TRANS/WP.29/806
3 August 2001

DRAFT SUPPLEMENT 1 TO THE 01 SERIES OF AMENDMENTS TO REGULATION No. 94

(Frontal collision protection)

Annex 10, amend to read:

Figure 1

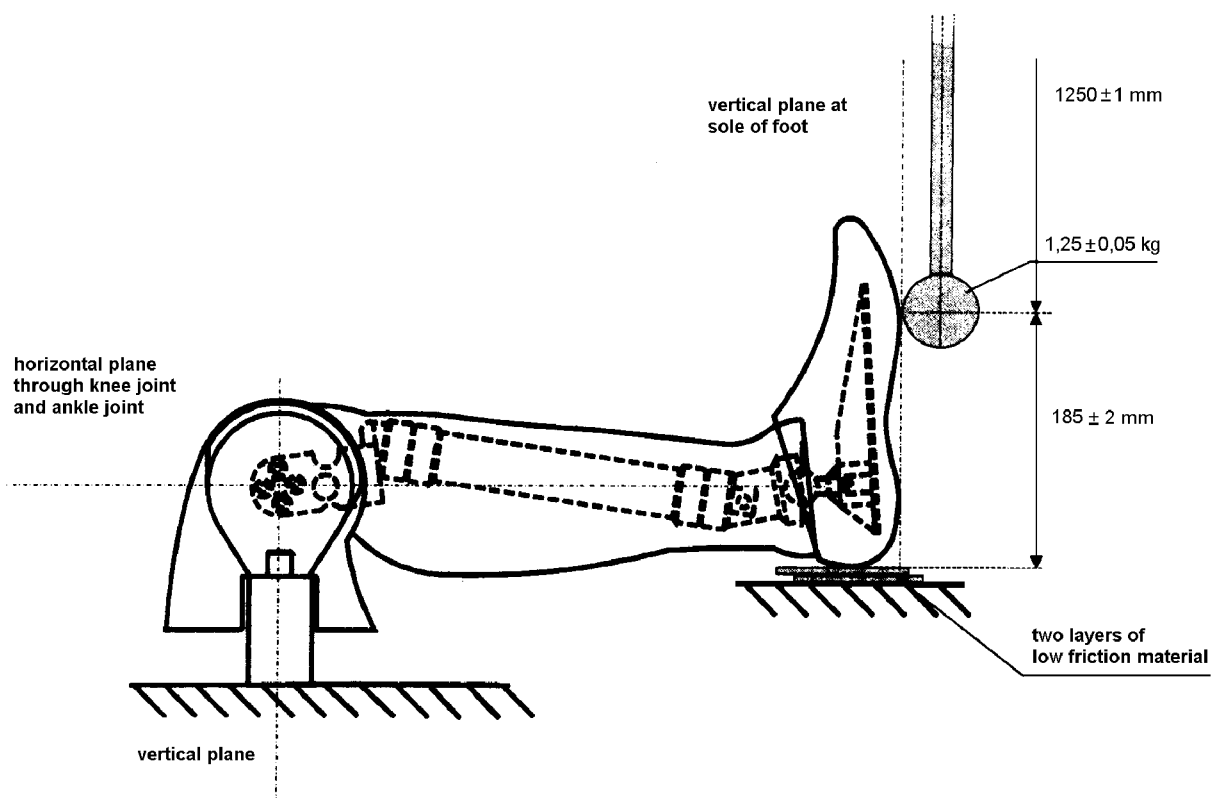
- 1.3.4. Mount the leg assembly to the fixture shown in Figure 1. The test fixture shall be rigidly secured to prevent movement during impact. The centre line of the femur load cell simulator (78051-319) shall be vertical with a tolerance of $\pm 0.5^{\circ}$. Adjust the mount such that the line joining the knee clevis joint and the ankle attachment bolt is horizontal with a tolerance of $\pm 3^{\circ}$, with the heel resting on two

sheets of a flat low friction (PTFE sheet) surface. Ensure that the tibia flesh is located fully towards the knee end of the tibia. Adjust the ankle such that the plane of the underside of the foot is vertical and perpendicular to the direction of impact with a tolerance of $\pm 3^\circ$ and such that the mid sagittal plane of the foot is aligned with the pendulum arm. Adjust the knee joint to 1.5 ± 0.5 g range before each test. Adjust the ankle joint so that it is free and then tighten just sufficiently to keep the foot stable on the PTFE sheet.

- 1.4. Performance specification
 - 1.4.1. When each ball of the foot is impacted at $6.7 (\pm 0.1)$ m/s in accordance with paragraph 1.3., the maximum lower tibia bending momentum about the y-axis (My) shall be 120 ± 25 Nm.

Figure 2

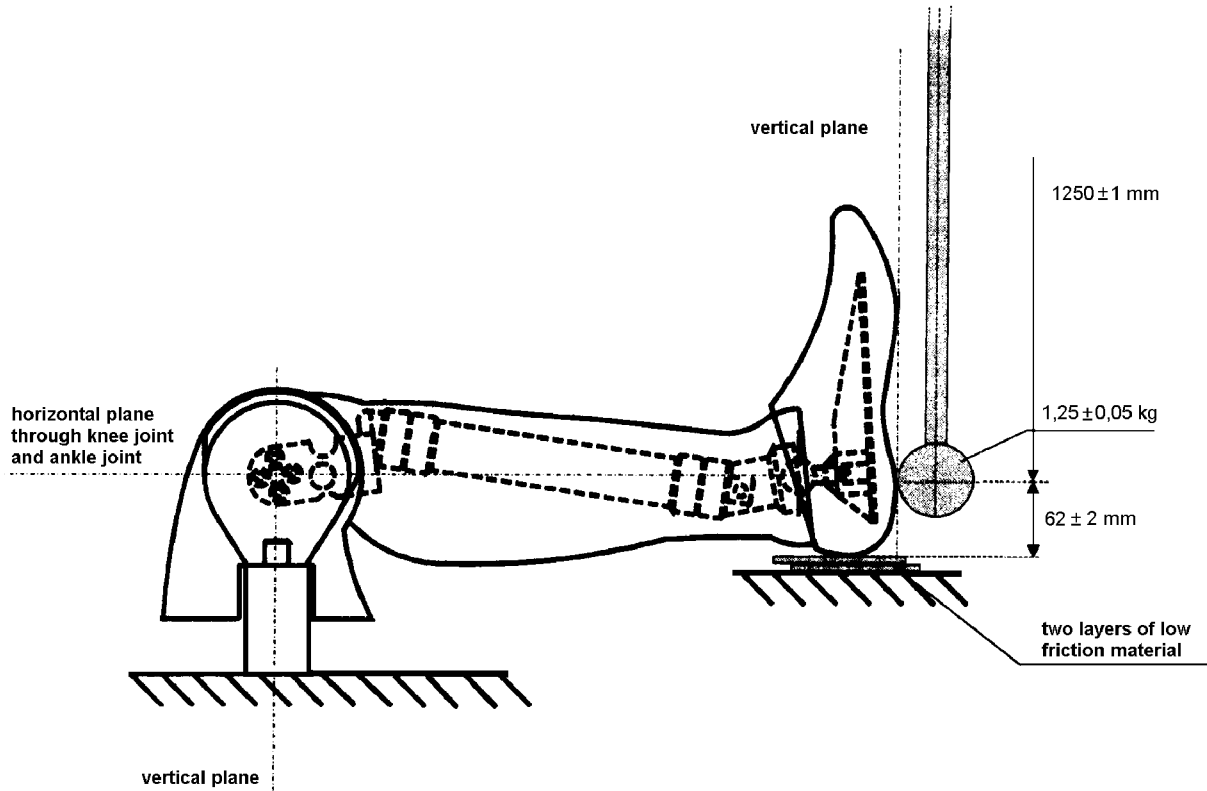
- 2.3.3. Align the impactor accelerometer with its sensitive axis parallel to the impactor longitudinal centre line.
- 2.3.4. Mount the leg assembly to the fixture shown in Figure 2. The test fixture shall be rigidly secured to prevent movement during impact. The centre line of the femur load cell simulator (78051-319) shall be vertical with a tolerance of $\pm 0.5^\circ$. Adjust the mount such that the line joining the knee clevis joint and the ankle attachment bolt is horizontal with a tolerance of $\pm 3^\circ$ with the heel resting on two sheets of a flat low friction (PTFE sheet) surface. Ensure that the tibia flesh is located fully towards the knee end of the tibia. Adjust the ankle such that the plane of the underside of the foot is vertical and perpendicular to the direction of the impact with a tolerance of $\pm 3^\circ$ and such that the mid sagittal plane of the foot is aligned with the pendulum arm. Adjust the knee joint to 1.5 ± 0.5 g range before each test. Adjust the ankle joint so that it is free and then tighten just sufficiently to keep the foot stable on the PTFE sheet.

- 2.4. Performance specification
 - 2.4.1. When each heel of the foot is impacted at 4.4 ± 0.1 m/s in accordance with paragraph 2.3., the maximum impactor acceleration shall be 295 ± 50 g.

Figure 3

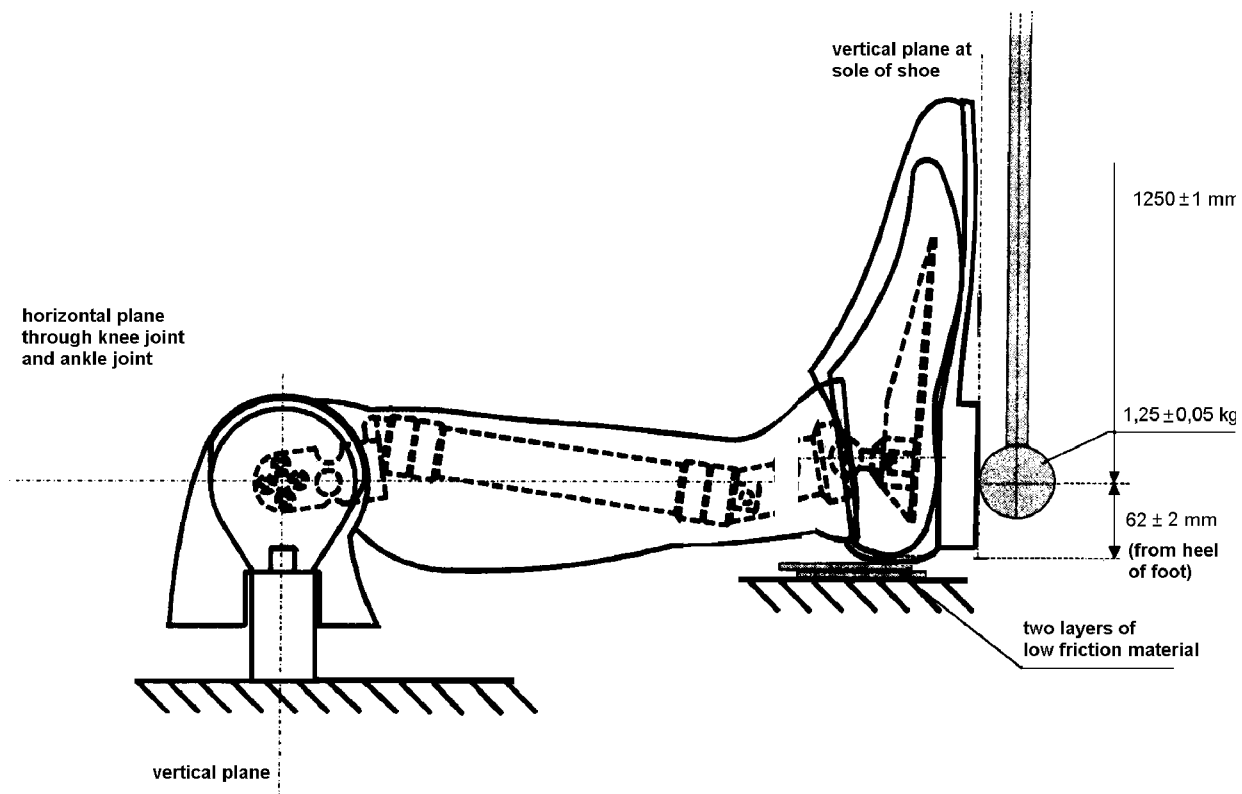
- 3.3.3. Align the impactor accelerometer with its sensitive axis parallel to the impactor longitudinal centre line.
 - 3.3.4. Mount the leg assembly to the fixture shown in Figure 3. The test fixture shall be rigidly secured to prevent movement during impact. The centre line of the femur load cell simulator (78051-319) shall be vertical with a tolerance of $\pm 0.5^\circ$. Adjust the mount such that the line joining the knee clevis joint and the ankle attachment bolt is horizontal with a tolerance of $\pm 3^\circ$, with the heel of the shoe resting on two sheets of a flat low friction (PTFE sheet) surface. Ensure that the tibia flesh is located fully towards the knee end of the tibia. Adjust the ankle such that a plane in contact with the heel and sole of the underside of the shoe is vertical and perpendicular to the direction of impact with a tolerance of $\pm 3^\circ$ and such that the mid sagittal plane of the foot, and shoe is aligned with the pendulum arm. Adjust the knee joint to 1.5 ± 0.5 g range before each test. Adjust the ankle joint so that it is free and then tighten just sufficiently to keep the foot stable on the PTFE sheet.

shall be $1,250 \pm 1$ mm. The impact cylinder is mounted with its longitudinal axis horizontal and perpendicular to the direction of impact. The pendulum shall impact the heel of the shoe in a horizontal plane which is a distance of 62 ± 2 mm above the base of the dummy heel when the shoe is resting on the rigid horizontal platform, so that the longitudinal centre line of the pendulum arm falls within one degree of a vertical line at impact. The impactor shall be guided to exclude significant lateral, vertical or rotational movement.

- 3.3.6. Allow a period of at least 30 minutes between successive tests on the same leg.
- 3.3.7. The data acquisition system, including transducers, shall conform to the specifications for CFC 600, as described in appendix 5 of this annex.
- 3.4. Performance specification
 - 3.4.1. When the heel of the shoe is impacted at 6.7 ± 0.1 m/s in accordance with paragraph 3.3, the maximum Tibia compressive force (F_z) shall be 3.3 ± 0.5 kN.
